BOARD OF ADJUSTMENT

Attached for your review is the packet for the February 1, 2007 session of the City of Chesterfield Board of Adjustment. The agenda and meeting packet are now also available on the City of Chesterfield website in the "Agendas" section.

BEFORE THE BOARD OF ADJUSTMENT FOR THE
CITY OF CHESTERFIELD, MISSOURI

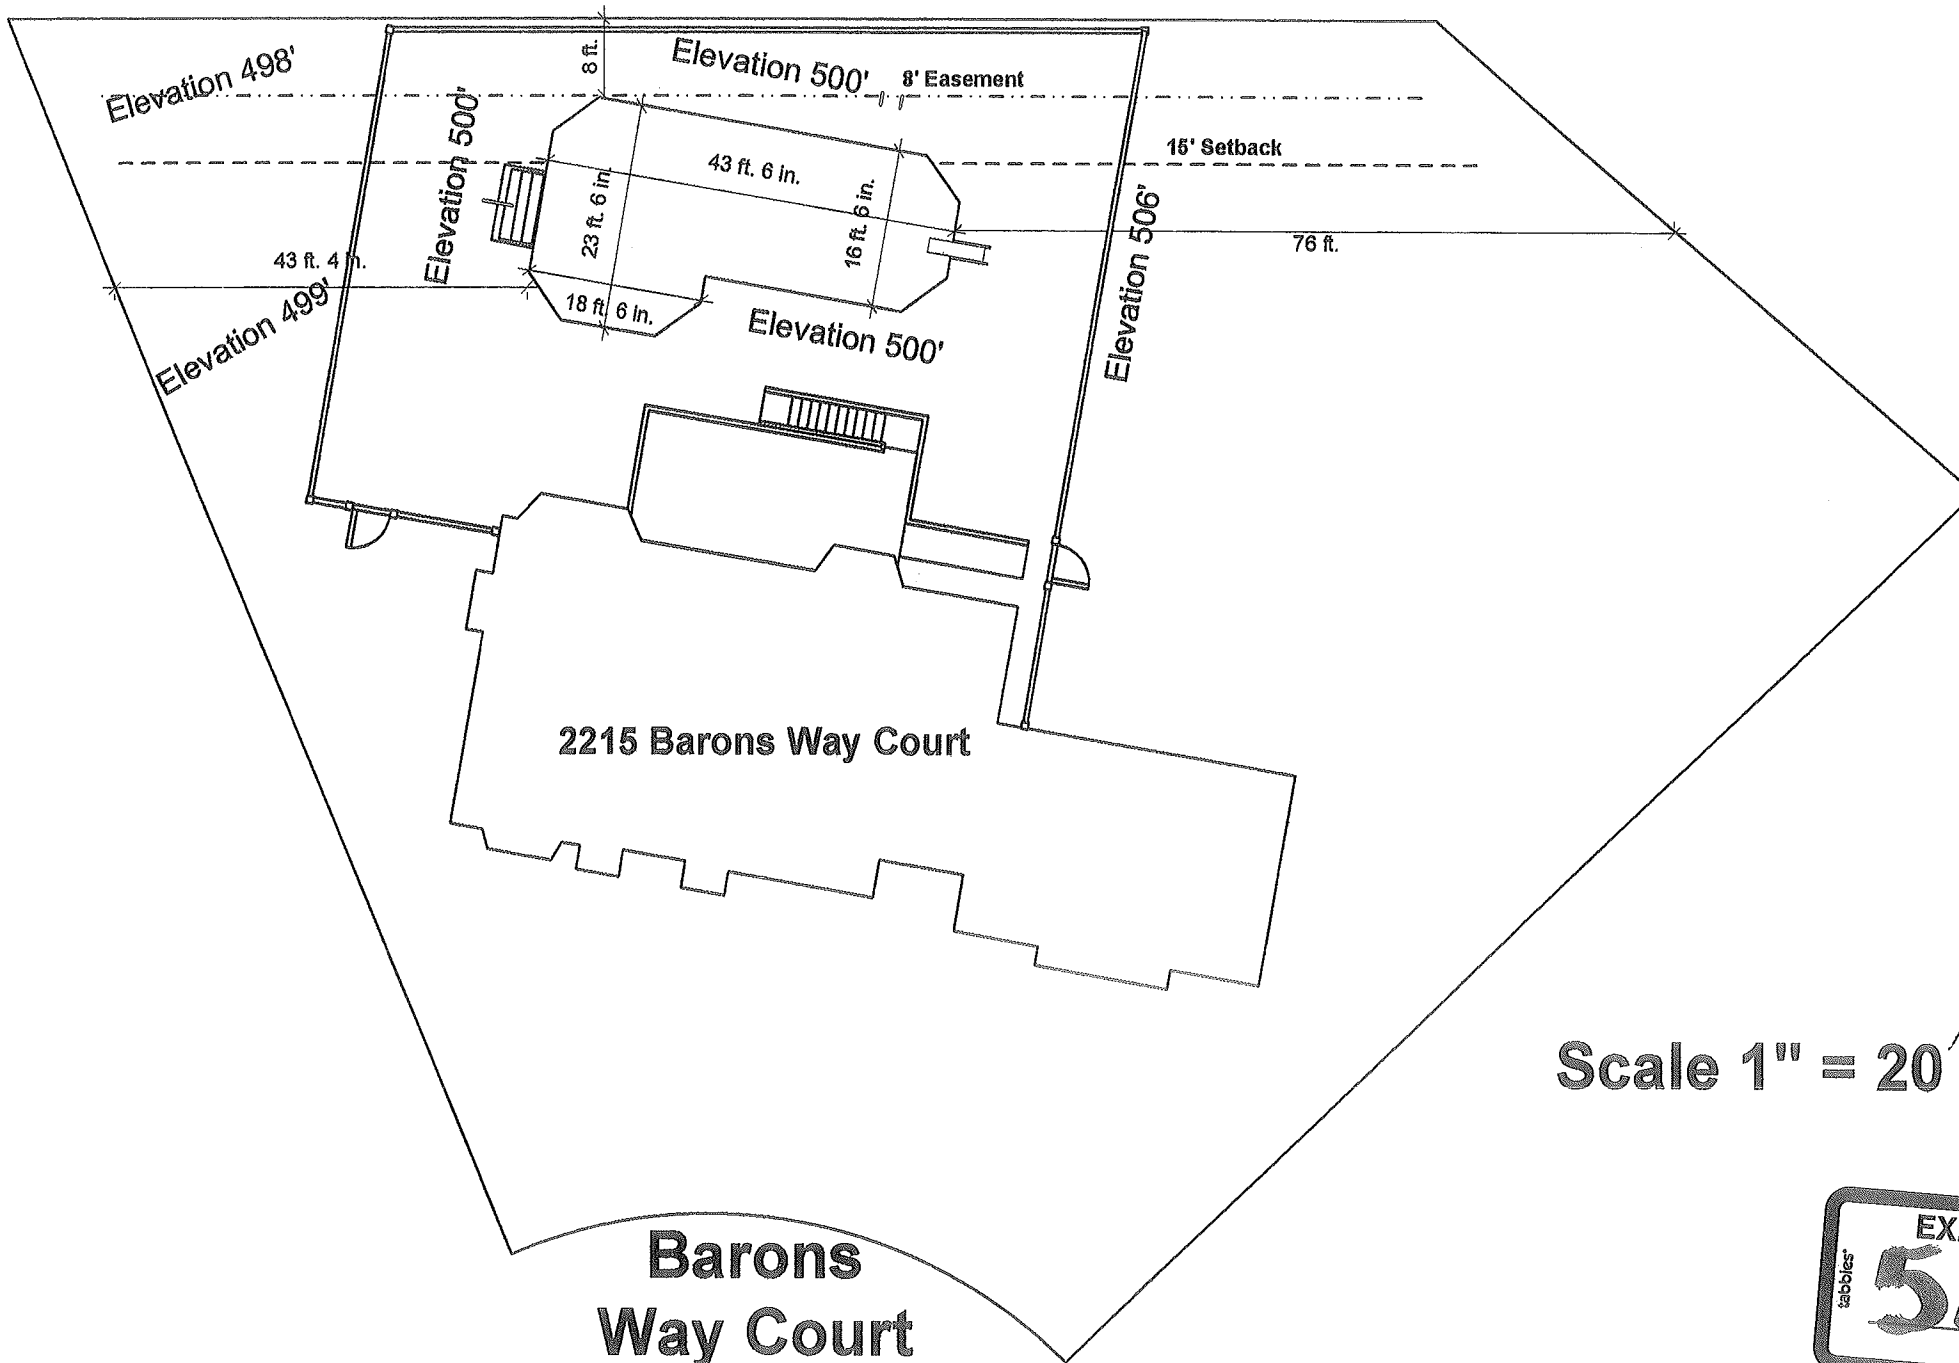
We would like to update our application to request an 8 foot rear setback instead of the 5 foot rear setback the board reviewed on 1.04.07. Our contractor feels that this proposal is the best option given the layout of the yard. See attached copies of new site plan.

1. Shift pool to the right: Due to the existing elevation of the yard, shifting the pool to the right would require installing a 6 foot retaining wall. As a result this would alter the contour of the land and impact the existing flow of water.
2. Shift the pool to the left: After reviewing this option with the subdivision board of trustees, it is the practice of the current board to require all structures to remain behind the house. In addition this would also alter the existing elevation of the yard and cause a problem with water flow to the existing county storm sewer line. The main problem with this option however is that it would cause us to move within the MSD easement.
3. Shift to pool toward the home: Our current site plan moves the pool within 8 feet of the existing deck structure. This enables us to remain in compliance with IRC codes 2005.

EXHIBIT THREE

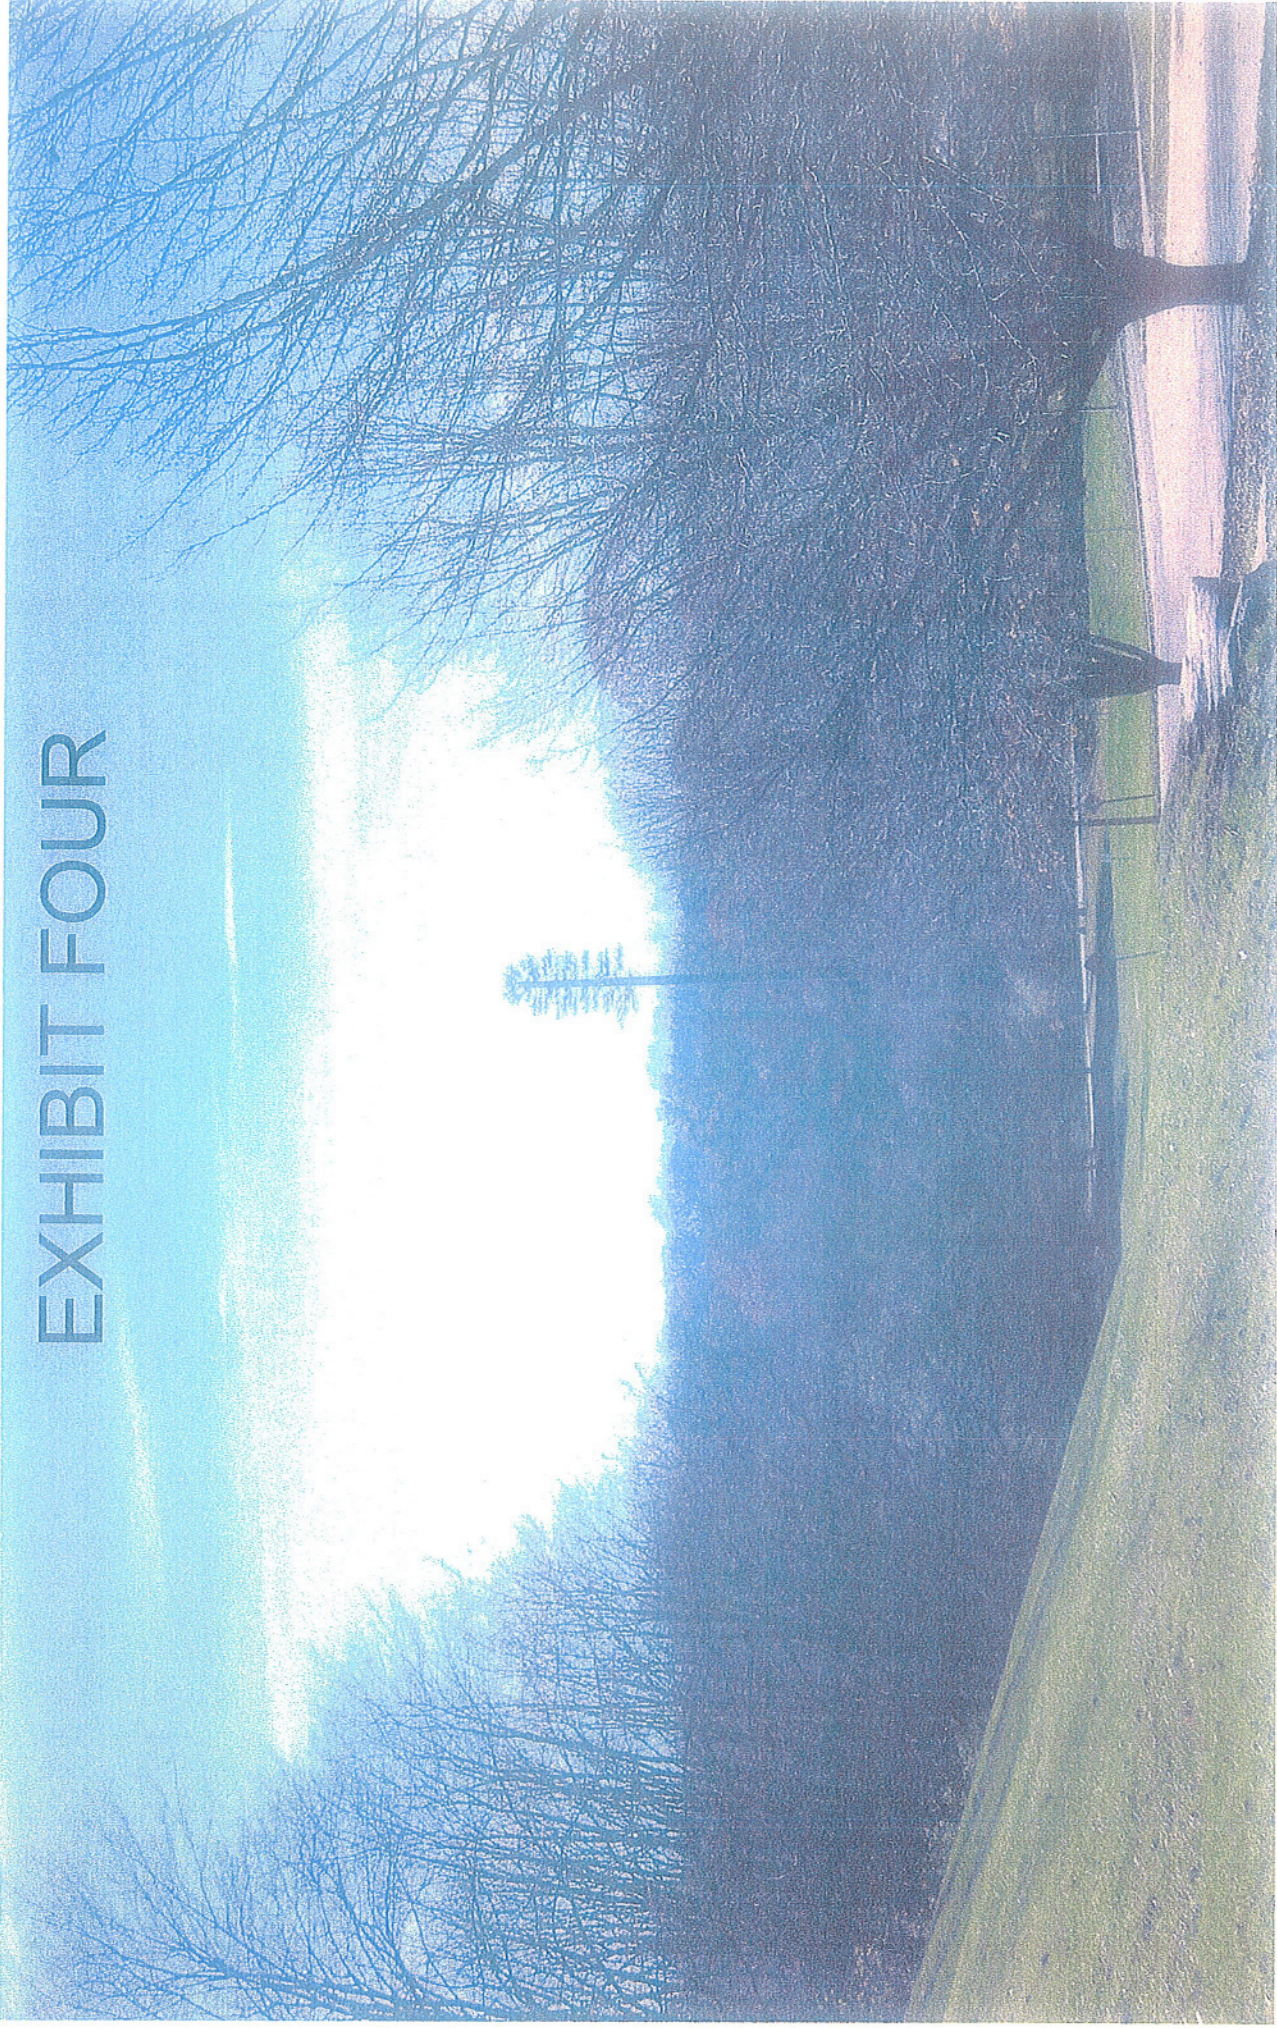
² Part of the reason the tower as constructed thus far is so visible is because it is being constructed in the wrong place. A Registered Land Surveyor compared the application as approved by the Director to the actual location of the tower construction. The surveyor's findings show that the tower is being constructed 45.6 feet further south than the location approved by the Director, 115 feet further west than the approved location. This has moved the tower up the hill and has resulted in the base of the tower being approximately 30' higher than approved by the Director. (The surveyor's findings are attached hereto as Exhibit 5; also see city photograph attached hereto as Exhibit 6).
